Access Compliance Report Public Rights-of-Way (Curb Ramps)

Main Street: HEWES_ST		Cross Street: FOWLER_AVE		Location:	NE
ADA ID: RPRK211006165112	Ramp Type:Type 1 - Perpendicular Diagonal Initial Pass/Fail: Fail		Overall Compliance: No	Severity Score:	30
Codes/Mitigation Info/Possible Solution			Field Measurements/Component Compliance

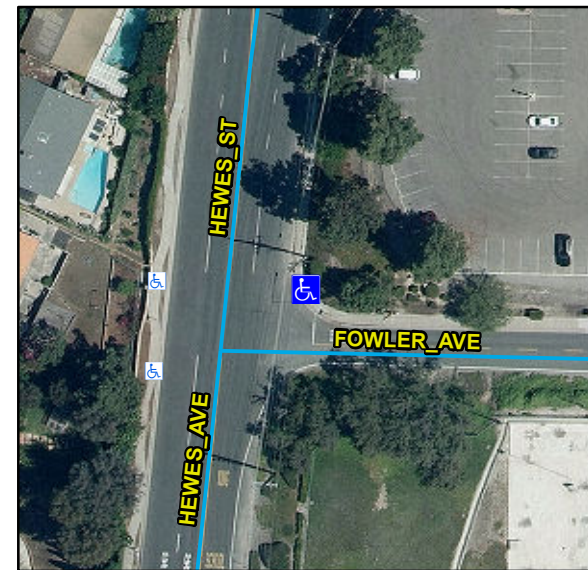
R304.2.2, R304.5.3, STD 1115

Remove & Replace Curb Ramp With Two New Directional Ramps or Equivalent.
